April 6, 1998

Subject: Request for additional information (TAC No. MA1069) regarding the University of Virginia Reactor "UVAR" (Docket No. 50-62, License R-66) and the U.Va. "CAVALIER" (Docket No. 50-396, License R-123) Technical Specification Amendment Requests.

Figure 6.1 Organizational Structure of the U.Va. Research Reactor Facility

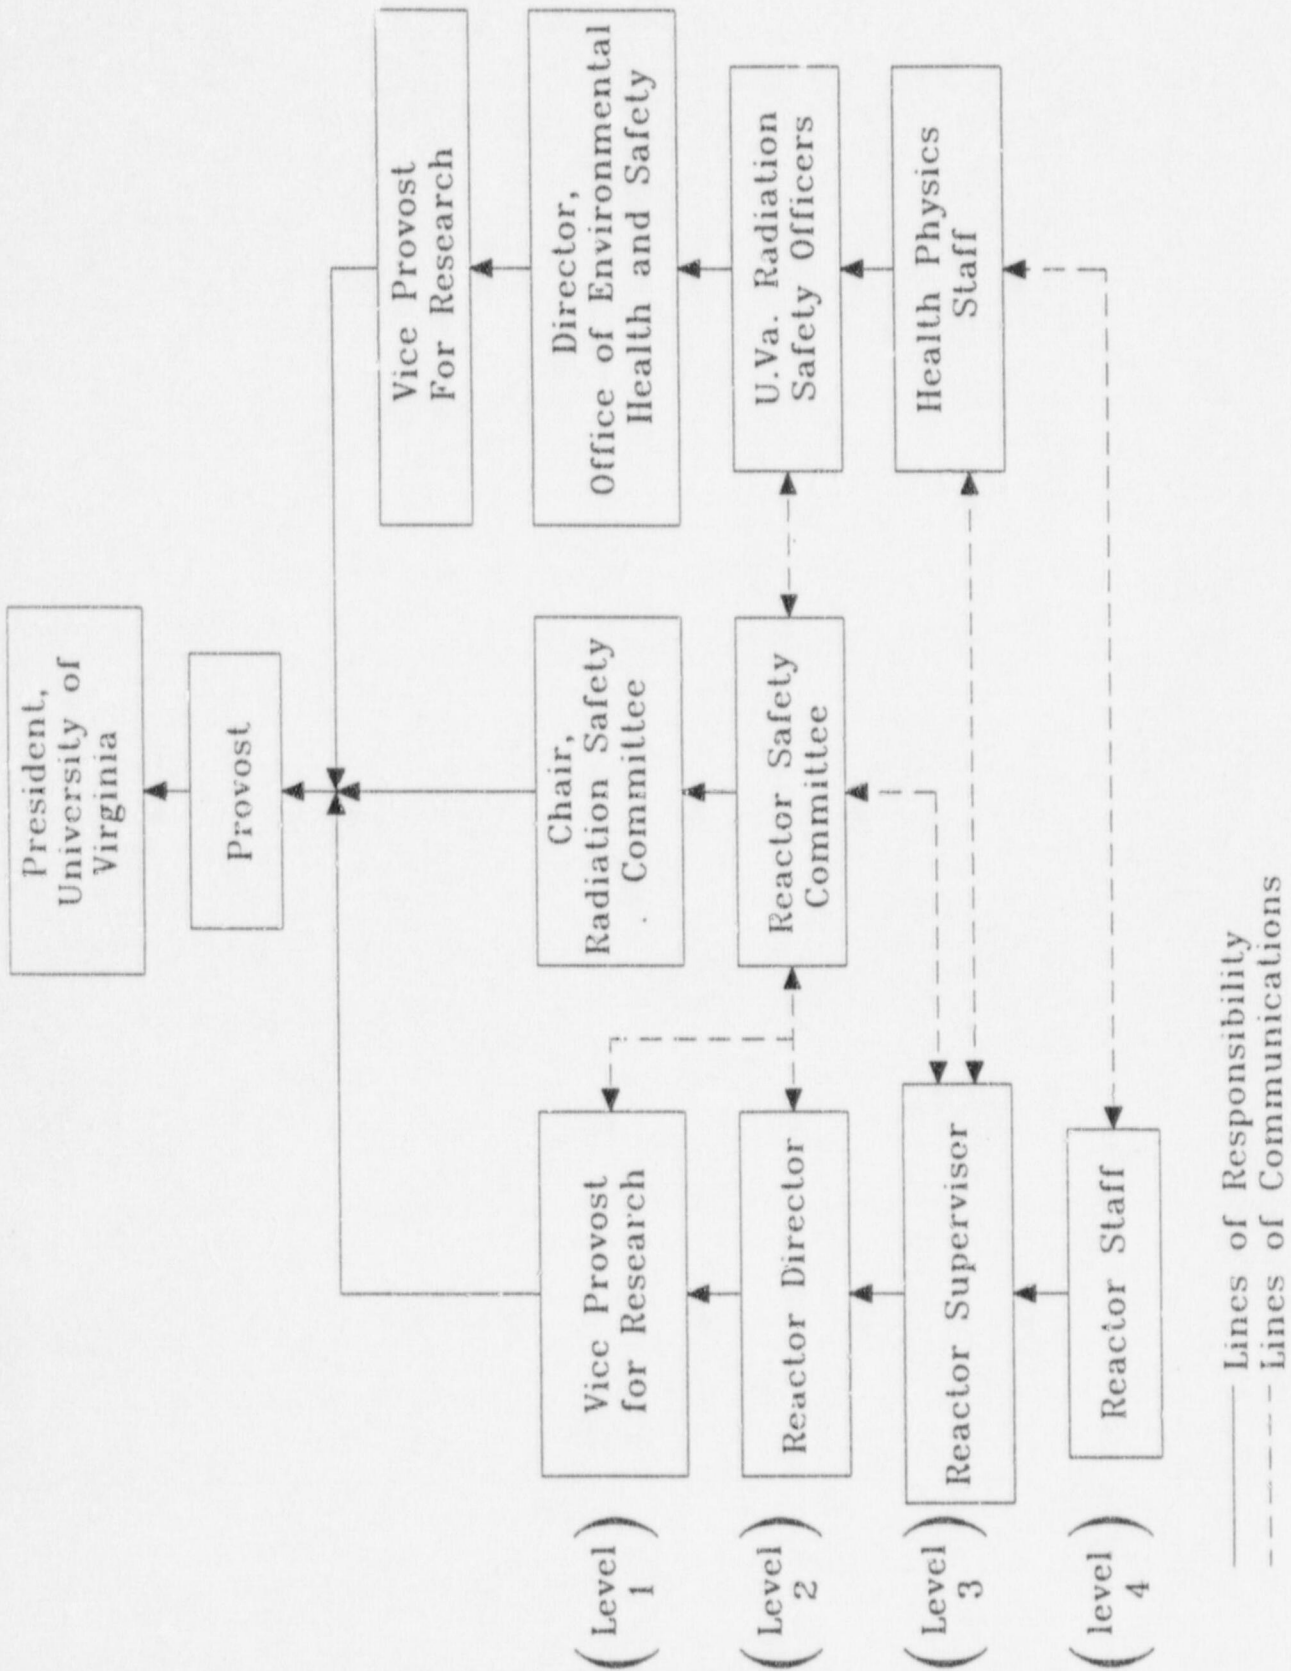
- a) Please explain the elimination of the Dean of the School of Engineering and Applied Science (SEAS) from the organizational structure and,
- b) the replacement of the Associate Provost for Research with the Vice Provost for Research.
- c) Why will the requested changes result in no reduction in the attention given by the University to safe and regulatory-compliant facility operation?

- a) The U.Va. Provost and SEAS Dean have agreed that the UVAR Facility should be considered a university resource and, as such, the responsibility for its future management and operation more properly rests with the Provost's Office, which has a greater access to resources.*
- b) The title of Associate Provost for Research has been changed to Vice Provost for Research. Therefore, this is simply a change in title and not an administrative change.*
- c) Following the approval of the revised Technical Specifications, the Reactor Director will report to the Provost's Office, which is administratively at a higher level than the Nuclear Engineering Department or the School of Engineering. It can be concluded that the supervisory attention given to nuclear operations would henceforth be at the same level, and perhaps higher than at present.*

The Reactor Facility shall be an integral part of the University of Virginia. The organizational structure of U.V.A. relating to the Reactor Facility is shown in Figure 6.1. The Vice Provost for Research will have overall responsibility for management of the Facility (Level 1).

Figure 6.1 Organizational Structure of the U.Va. Research Reactor Facility

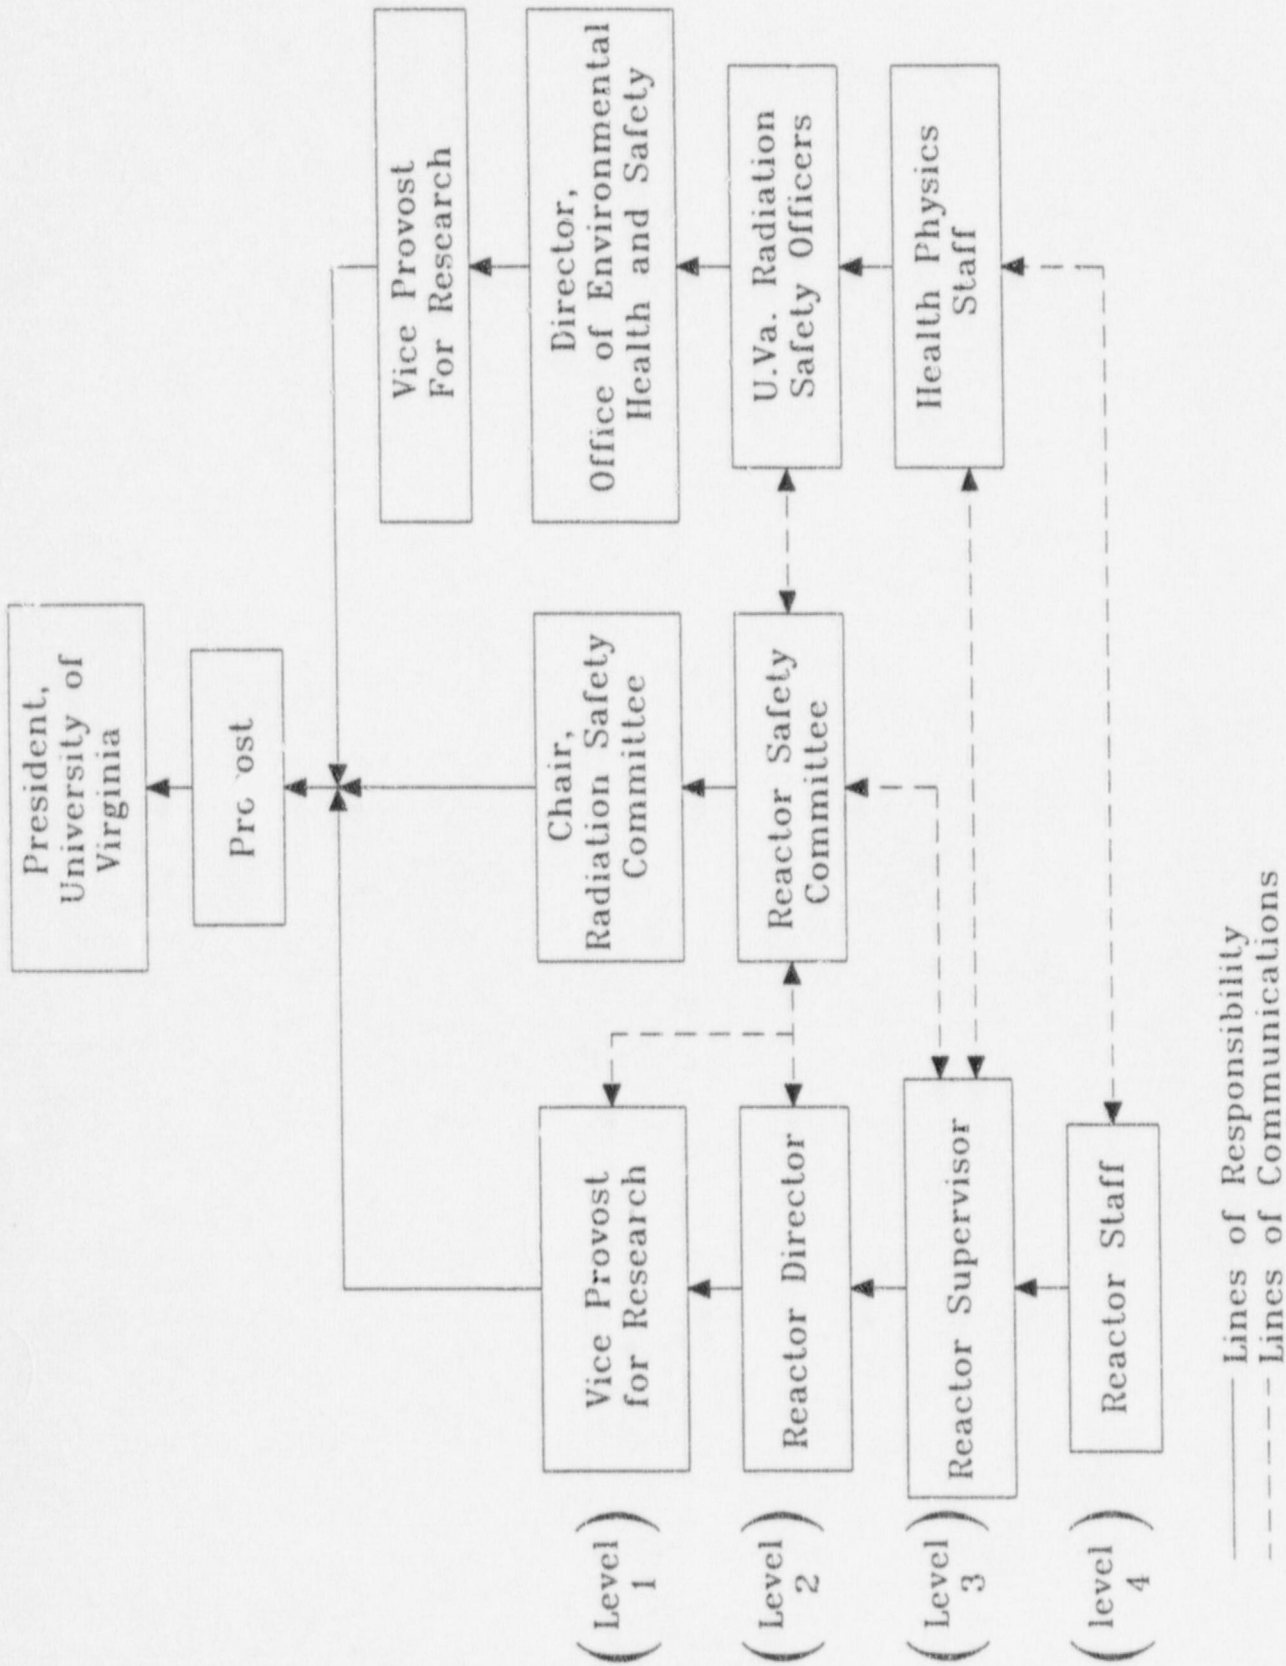
Do your proposed administrative changes affect the license or decommissioning order for the CAVALIER Research Reactor? If so, please submit an application for the amendment of the CAVALIER license.

*The NRC has issued a decommissioning order for the CAVALIER. Until its license has been terminated, administrative changes such as those proposed for the UVAR TS must also be made to the CAVALIER TS, in parallel. Please find included in this submittal proposed modifications to CAVALIER TS which are essentially identical to those proposed for the UVAR license. Also included are proposed changes to pertinent pages in the CAVALIER Decommissioning Plan and its NRC Decommissioning order which would be affected by the requested organizational change.*

The reactor facility shall be an integral part of the University of Virginia. The organizational structure of UVA relating to the reactor facility is shown in Figure 6.1. The Vice Provost for Research will have overall responsibility for management of the facility (Level 1).
